File: A140/20

Staff Report Prepared By: Pravina Attwala
Hearing Date: Thursday, April 29, 2021

Minor Variance Application

- Applicant:** Lidia Cosentino
- Agent:** Cameron O'Neill
- Property:** **607 Velmar Dr Woodbridge**
- Zoning:** The subject lands are zoned R2 Residential Zone Two, and subject to the provisions of Exception No. 9(769), under By-law 1-88 as amended.
- OP Designation:** Vaughan Official Plan 2010 ('VOP 2010'): "Low-Rise Residential"
- Related Files:** None
- Purpose:** Relief from By-law 1-88, as amended, is being requested to permit the construction of a cabana and covered porch to be located in the rear yard.

SITE PLAN

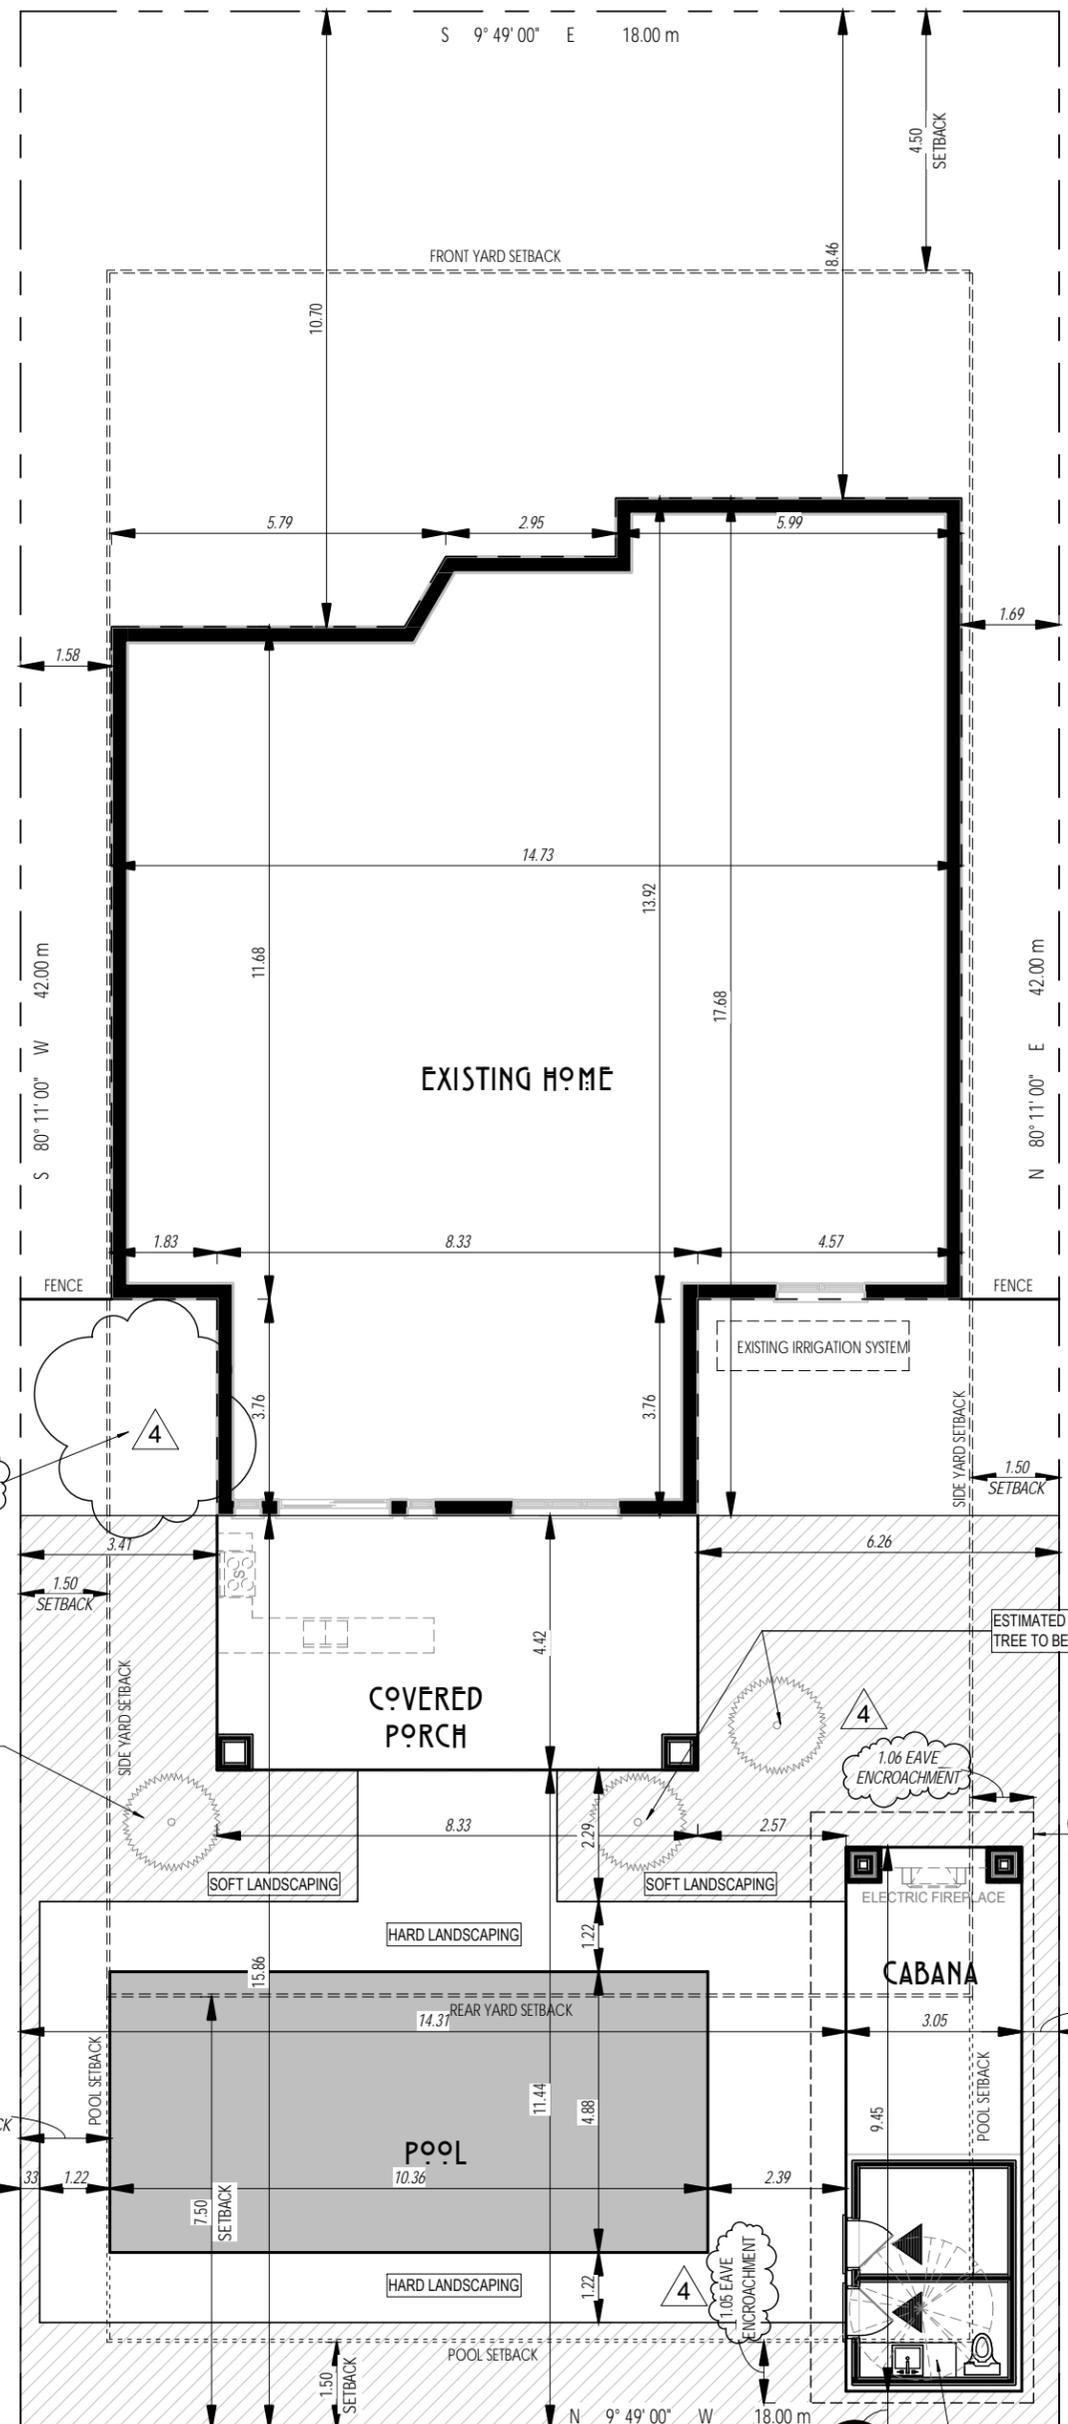
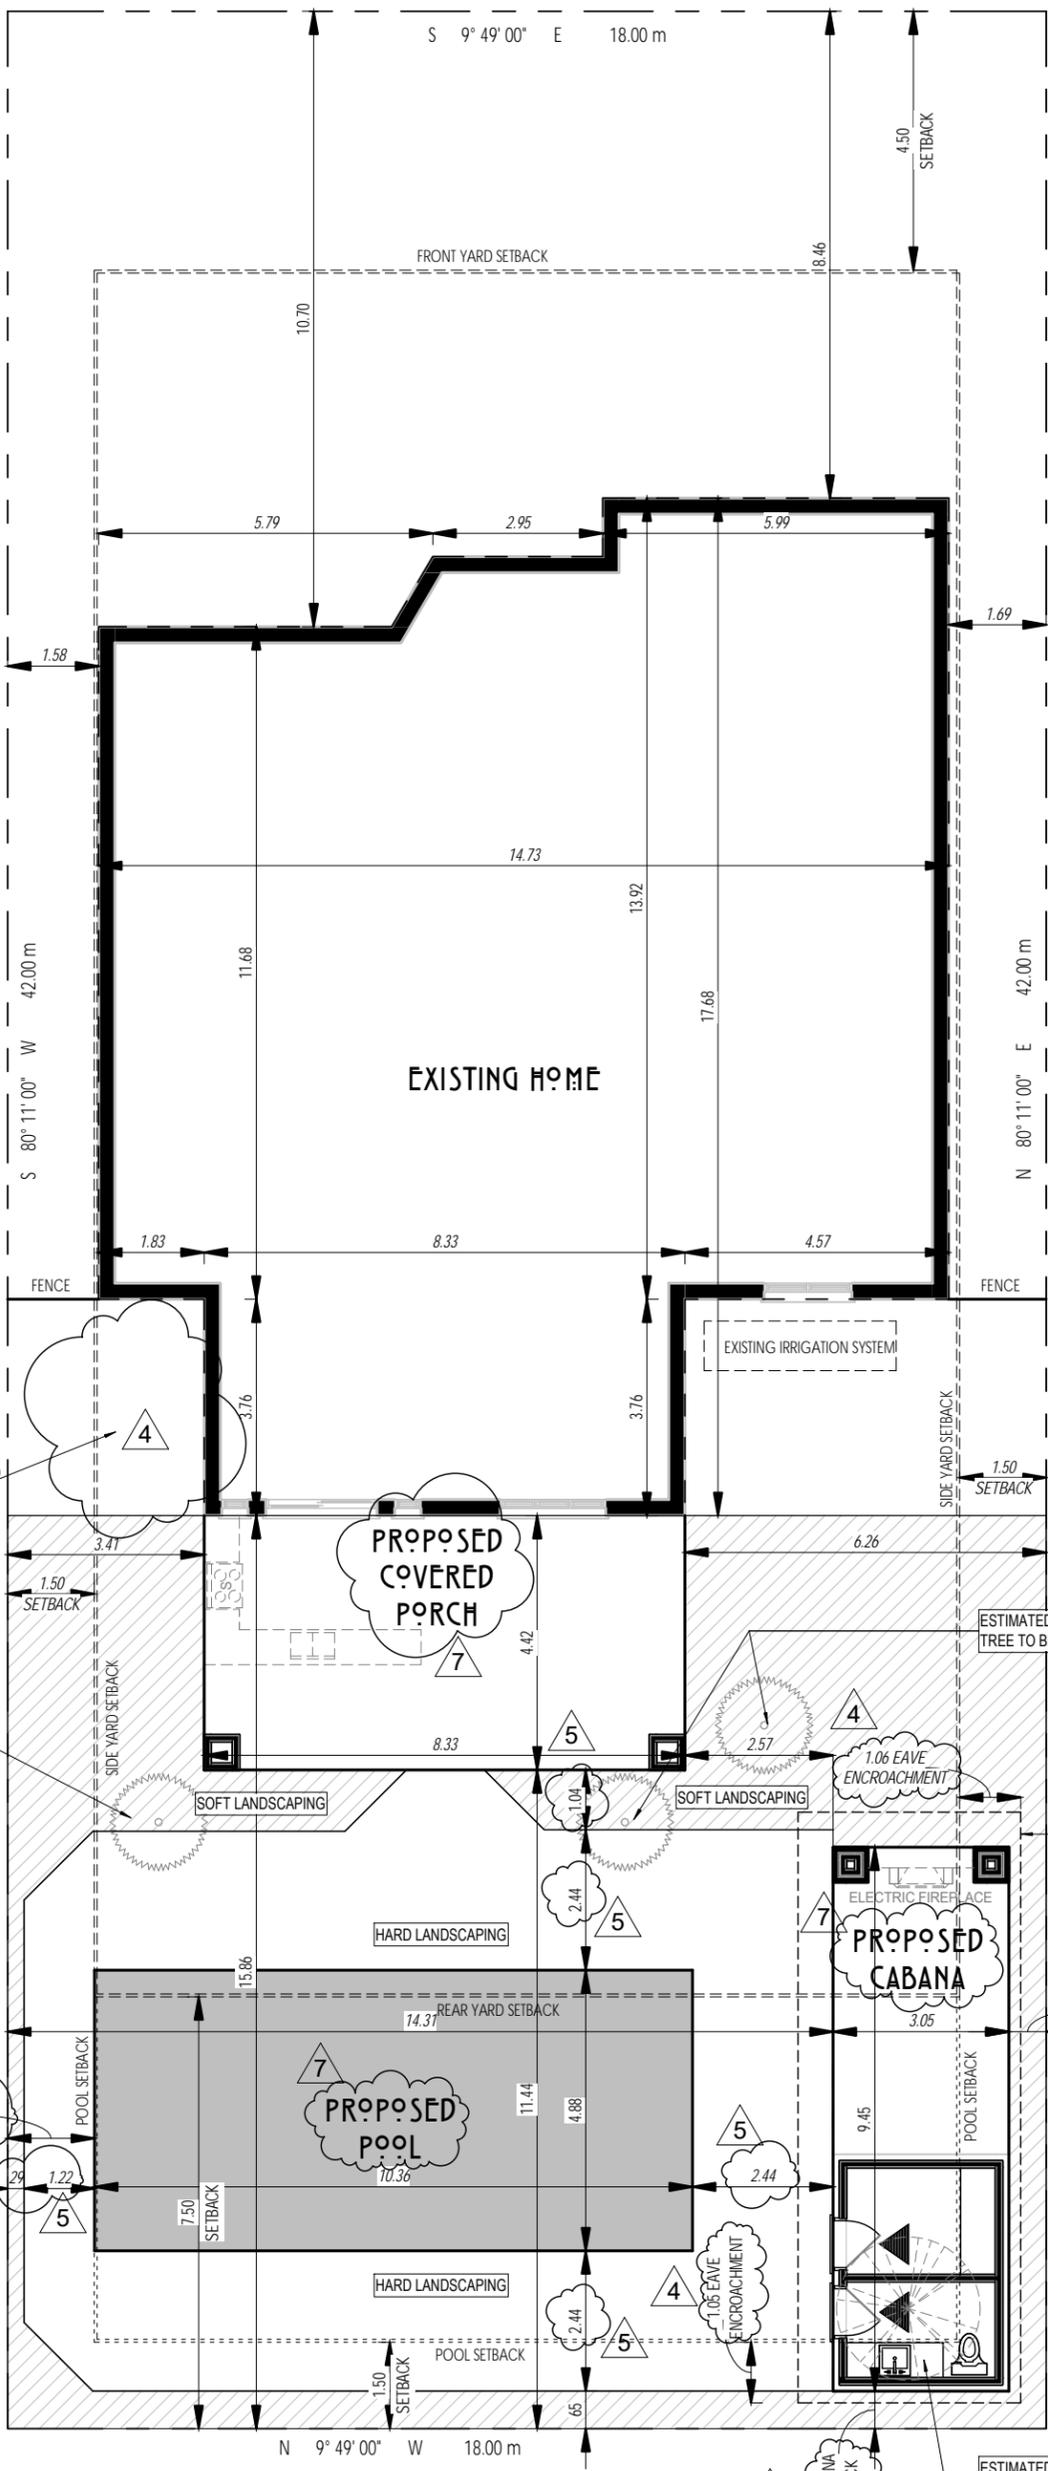
The lot coverage breakdown is 29.22% for the dwelling, 4.87% for the covered porch and 3.80% for the accessory building (cabana).

The eave and gutter projection of 0.20 metres abutting the interior side lot line complies with the maximum encroachment of 0.50 metres.

An air conditioning unit and/or pool equipment (open) shall be setback a minimum of 0.60 metres from the interior side lot line; and may encroach a maximum of 1.5 metres into the required rear yard of 7.5 metres.

The applicant shall install tree protection hoarding for the two front boulevard trees (1 each side of the driveway) prior to the start of any site work. Hoarding is to comply to design MLA 107B.
